pd-trigger — Design Document

hwde v1 pipeline
generated 2026-09-24 12:39:01

Board review (P8 adversarial) - pd-trigger

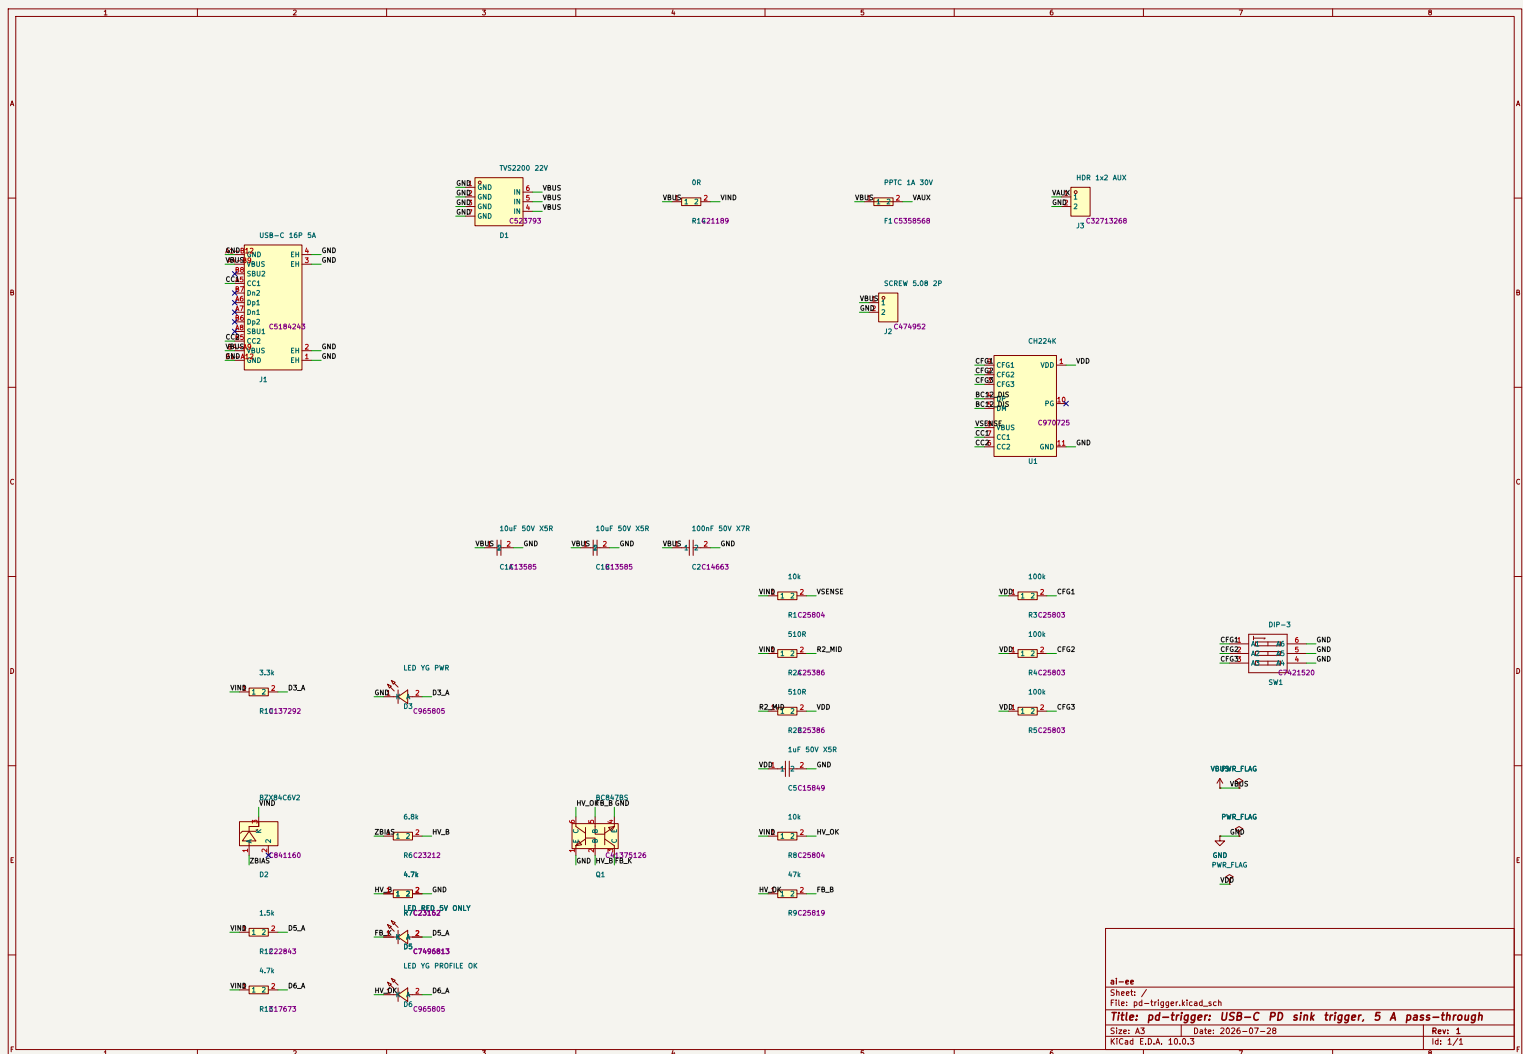
W1 dp-dm-short-at-chip: architecture's PD-only short (/BC12.DIS) ACCEPTED by the reviewer as hardware-SAFER than the datasheet's connector wiring (removes a 21V-onto-3.8V-abs-max fault path). Cost: no QC/BC legacy support - the board is "PD sources only"; goes on B.SilkS + order docs. W2 vdd-worst-corner: true worst case 0.979mA at 4.4V low-line all-straps- closed vs unpublished CH224K IDD - bounded by WCH's own reference circuit; V1 bring-up step: measure VDD at the 5V profile; contingency = both 510R -> smaller (documented floor 600R total). Bring-up addenda: buzz out Q1 E/B/C once (clone PDF JS-gated; Nexperia- standard pinning verified as the compatibility claim).

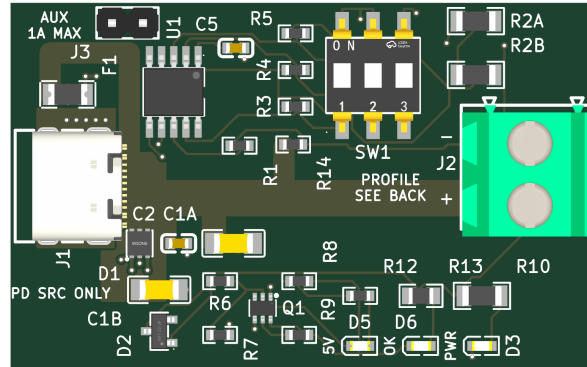
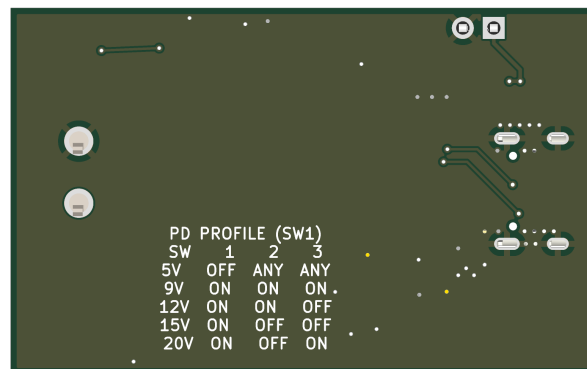
E1 - 5 A return chokes at J1's GND contact pads (error, checker-blind by design D7)

The 4 GND cable contacts land on two merged SMD pads (F.Cu only): A1-B12 at (17.63,39.31) and B1-A12 at (17.63,45.71), nominally 2.5 A each at the 5 A rating. Their ONLY copper into the B.Cu return pour:

- A1-B12 (top): a 0.2 mm wide, 2.7 mm long F.Cu chain (3 segments) into shell pad 1's THT barrel, plus one 0.6/0.3 via whose annulus grazes the pad corner by ~0.05 mm (etch-tolerance-level). 0.2 mm at 2 oz = 0.80 A capacity at 10 C rise (pipeline model); at 2.5 A the same model gives ~133 C rise (short-neck heatsinking will moderate this, but it is a >3x overcurrent on the model's own terms). ~13.6 squares = 3.3 mohm.
- B1-A12 (bottom): a 0.2 mm x 1.3 mm trace into ONE 0.6/0.3 via. The board's own via budget (constraints via_amps 0.5) says 2.5 A needs 5 vias; there is 1. Shell pad 4 sits 0.32 mm away but is NOT connected on F.Cu - its copper does not help.

Architecture D7/power_tree structural requirement ">= 10 vias at J1's GND pads" (the stated substitute for keeping GND out of power[] so check_current stays quiet): not delivered. DRC cannot see it (0.2 mm is netclass-legal), check_current cannot see it (GND undeclared), check_return_path no-ops (no high_speed key). Failure mode: sustained 5 A at any profile heats the two necks far past the 10 C design intent; long-term trace/joint fatigue, intermittent ground, and full return current cascading onto the surviving 0.2 mm chain. Fix is cheap at P9: an F.Cu GND spandrel bonding each contact pad to its shell pad (the VBUS pour top edge is at y 39.7 - the strip above it, and the strip x < 17.2 plus the region south of y 46, are free) plus 4-5 vias per side.

E2 - Safety/waiver silk markings absent (error, promised artifact) Board-wide gr_text count is ZERO; B.SilkS carries nothing at all (both B.SilkS references in the file are the stackup layer table). Missing, each one a written promise:

- AUX 1A MAX + V+/GND at J3 (P0 answer 4 "silk-marked", V10). F1 makes overload safe-by-hardware, but polarity of the 2-pin aux header is unmarked.
- PD SOURCES ONLY (ERC waiver W1's standing condition: "goes on B.SilkS + order docs"). The waiver's silk half is currently unfulfilled.
- J2 screw-terminal polarity. Trunk lands on J2 pad 1 = the LOWER screw (board-bottom side); nothing anywhere tells the bench user which screw is V+. Reverse-wiring a load on a 100 W output is the single easiest field mistake this board can cause.

E3 - User-interface silk absent (error, promised artifact)

- The five-row profile table on B.SilkS - D3 calls silk "the user interface" and specifies the table verbatim; the bottom is a clean pour with room. Without it the ON/OFF-to-voltage map exists only off-board; a user WILL set 9 V expecting 12 V by trial and error. (Fail-safe floor: any wrong guess >= the 5 V fallback, and OFF-fail = 5 V - the mistake is bounded but real.)

- LED legends PWR / 5V ONLY / PROFILE OK (D4/V10): the render shows refdes D3/D5/D6 only. The entire P0-answer-6 "visible fallback indication" scheme is mute without the words - a lit red LED labeled "D5" indicates nothing.

W1 - J1 mouth recessed ~0.4-0.5 mm behind the board edge (warning, flagged at P6) Courtyard/silk front edge $x = 10.18$ vs board edge $x = 9.8$. USB-C receptacles are normally flush-to-overhanging; a recessed mouth lets thick/molded plug overmolds butt the board edge and hold the plug fractionally short of latch - intermittent CC, no PD, "works with some cables". On a bare bench board with arbitrary cables this is a real annoyance risk. Fix: nudge J1 -x 0.5-1.0 mm at P9 (pour edge follows; nothing else in that corridor), or accept and note in order docs.

W2 - Outline 48 x 30 mm exceeds the architecture's hard ceiling (warning, drift) Edge.Cuts = (9.8,27.51)-(57.8,57.51) = 48 x 30 mm. D9: nominal 45 x 25, "hard ceiling 48 x 28 mm"; 30 mm violates D9's own ceiling by 2 mm even though it equals P0 answer 5's literal +20 % (40x25 -> 48x30, +44 % area vs the brief's target). No digest discloses the growth past D9. Consequence is cost/footprint only, but it must be disclosed to the user at the checkpoint rather than discovered.

A1 - J2 GND pad ties to the return pour through 4 thermal spokes (advisory) J2 pad 2 (THT, 2.4 mm pad / 1.6 mm drill) connects via 4 x 0.5 mm diagonal spokes = 2.0 mm total at 2 oz -> model 8 C rise at 5 A. Legal and functional, but these are the most-loaded copper necks on the whole return after E1, at a hand-soldered joint. Recommend a solid-connect override (or a short fat GND strap) at P9; zero cost. (Verified all 4 spokes present; the VBUS pad 1 island below it is barrel-tied, normal.)

A2 - F1's VBUS feed branch is 18.3 mm long (advisory, V8 letter-violation) V8/D8 wanted all five VBUS taps hugging the run with 2-3 mm stubs. D1, C1A, C1B, C2, R14 comply; F1's feed runs 8.4 + 6.5 + 3.4 mm at 1.75 mm width to the top-left corner. Width-compliant (V8's actual purpose), carries ≤ 1 A in service; only cost is ~30 mm² of extra always-live 20 V copper. No action needed; recorded as drift.

A3 - Floating 0.65 mm² GND sliver at (20.0, 28.5) (advisory, cleanup) plane_repair's own dead-island fact (0 anchors), between J3/SW1 clearances. Cosmetic / minor DFM nit; remove at P9 cleanup or accept.

A4 - /VAUX at PPTC max-non-trip current (advisory) /VAUX routes at 0.3 mm (required 0.25 at the declared 1.0 A -> 7 C). F1's worst sustained NON-trip current is ~1.8 A -> model 27 C rise on those runs until/unless the PPTC trips. Bounded, no damage threshold approached (70-80 C copper on a 20 V node); acceptable. Recorded so nobody "fixes" it blind later.
